# Access Compliance Report

## Public Rights-of-Way

| Intersection ID: 10018047               | Main Street: BROOKSTEAD MEADOW CT | Cross Street: N/A                       | Location: SE           |
| ADA ID: 1290DE387C69                    | Ramp Type: BlendTrans1            | Initial Pass/Fail: Fail                 | Overall Compliance: No |

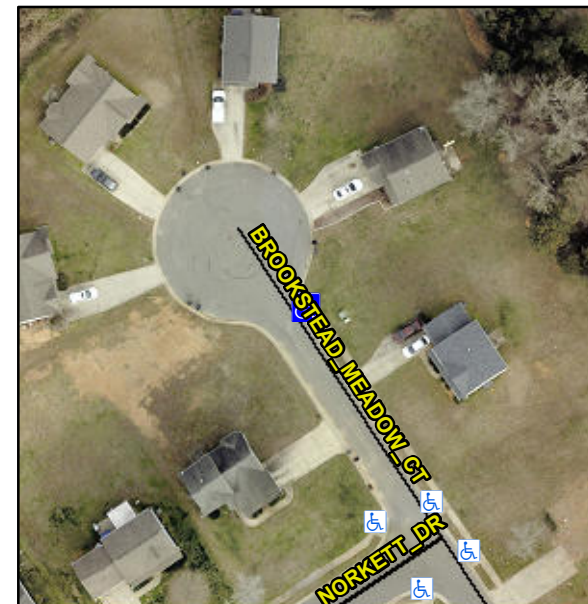
**Remove & Replace Curb Ramp With Two New Directional Ramps or Equivalent.**

**R304.5.1**

| Compliance | Description           | Data | Compliance | Description                 | Data |
|------------|-----------------------|------|------------|-----------------------------|------|
| No         | Ramp Width (in)       | 46.5 | Yes        | BlendTrans XSlope (%)       | 1.3  |
